Groundwater Review Summary Form

Application # G- 18301 *Re Review - 1 reduced rate*

TO: Water Rights Section Date 01/18/2017
 FROM: Groundwater Section Phillip I. Marcy
Reviewer's Name
 SUBJECT: Application G- 18301 Supersedes review of 06/14/2016
Date of Review(s)

A1. Applicant(s) seek(s) 3.0 cfs from 3 well(s) in the Powder Basin,
Baldock Slough subbasin

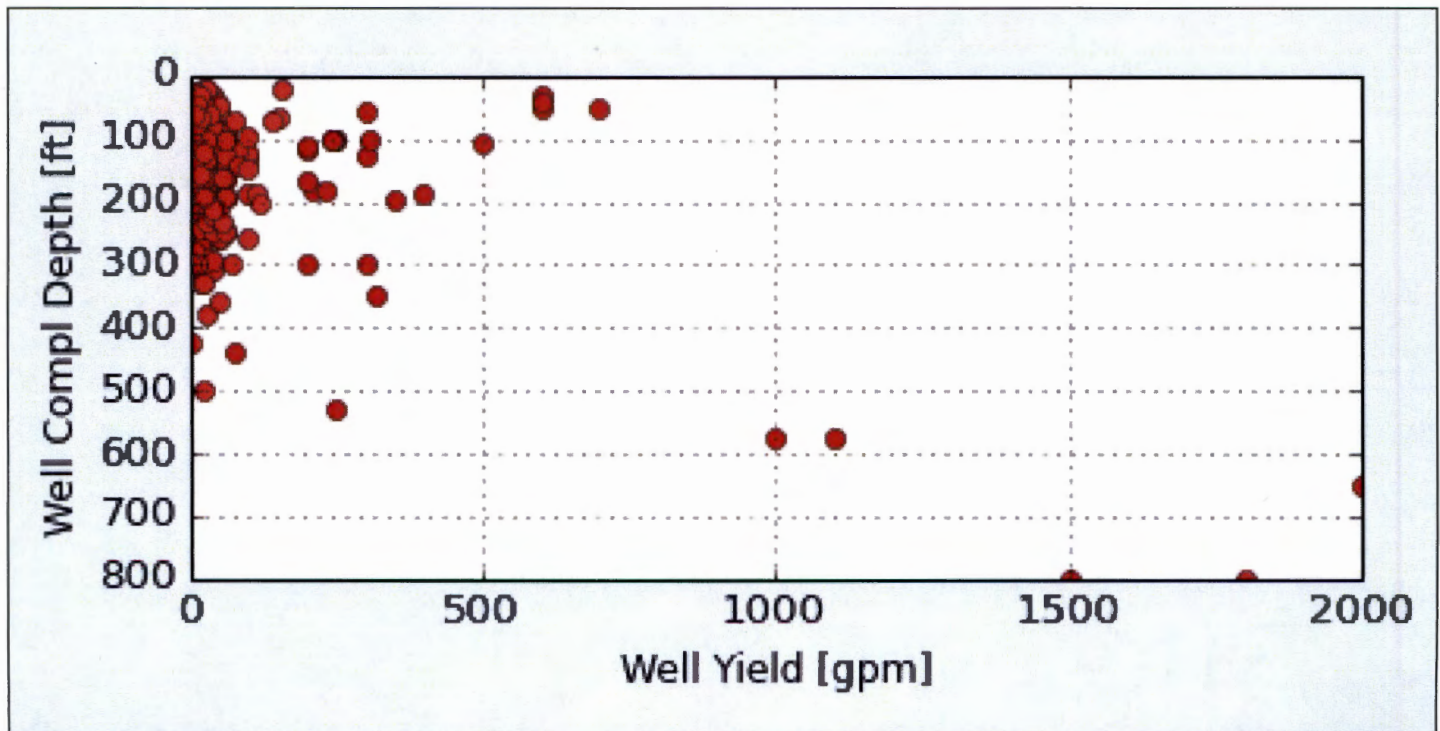
B3. **Groundwater availability remarks:** Wells producing 1000 or more GPM are infrequent in this area, and all are constructed to produce from fractured bedrock at considerable depth (greater than 500 feet, see Figure 2). The proposed POA locations are in close proximity to a ridge composed of Mesozoic intrusive and sedimentary rocks. These older rocks generally yield little groundwater, and well logs near the proposed POA locations report yields of less than 5 GPM from these units. Fractured volcanic units utilized by high yield wells to the west may not be present at the proposed locations, or may be present much closer to land surface where groundwater may not be present in any significant volume. Wells completed into these basalts within 100 feet of the land surface typically yield less than 50 GPM.

Figure 2: Statistics from well log reports in the vicinity of the proposed POA wells indicate that few wells obtain yields similar to those expected by the applicant (~1000 GPM). The few wells reporting 1000 GPM or greater are more than 500 feet deep, producing from fractured basalt flows buried much deeper than they are expected at the proposed POA locations.

Special Condition: Proposed POA wells shall not be constructed in a manner that allows production from shallow alluvium above volcanic rock, or from the fractured uppermost portions of the Powder River Volcanics. Wells penetrating the Powder River Volcanics must be continuously cased and continuously sealed to produce only from beneath no less than 10 feet of dense, unfractured bedrock.
